MotorGuide MARINE

service bulletin

Bulletin No. 2003-07

Incorrect Handle On Pontoon Models

a - Clicker used on extending handle only

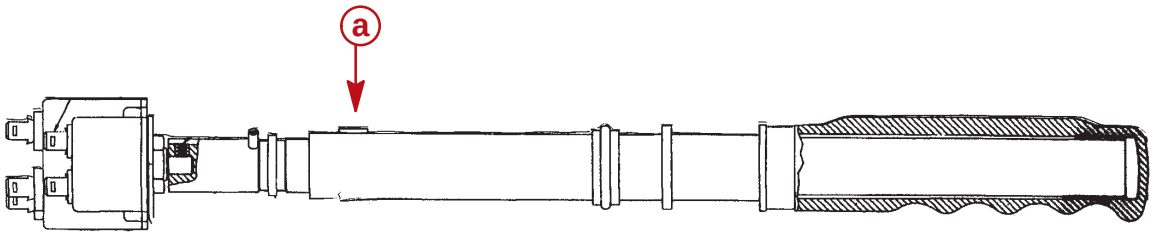
Manufacturing may have installed the incorrect non extending handles on the above listed pontoon model motors.

If a non extending handle is found on the above listed models within the listed serial number range, replace the handle with **P/N MBT372092**. If there is no clicker on the handle, it is a non extending handle and should be replaced.

Qty. One (1) MBT372092 Handle assembly
